# Service Update

## 53170 B+ Battery Cable Chafing

Reference Number: N162053170

Make	Model	Model Year		RPO	Description
		From	To		
GMC	Acadia	2017	2017

4640609

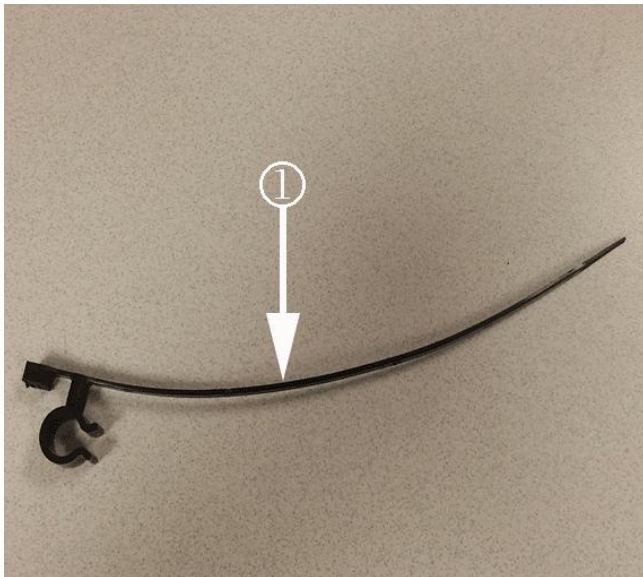
<b>Condition</b>	On certain vehicles the battery B+ cable may chafe from contact with the battery negative (engine block ground) cable. This physical contact may degrade the insulation on the B+ cable causing an eventual short, or loss of electrical power.
<b>Correction</b>	Dealers are to inspect the battery B+ cable for wear, replace if required and install a wire harness retention clip to obtain the required clearance between battery cables.

2. Inspect the battery positive cable (1) for damage due to contacting or chafing on the battery negative cable (2).
  - If there are NOT signs of damage to the battery positive cable, proceed to the next step.
  - If there are signs of damage to the battery positive cable, replace the battery positive cable and proceed to the next step. Refer to *Battery Positive Cable Replacement (LGX)* in SI.
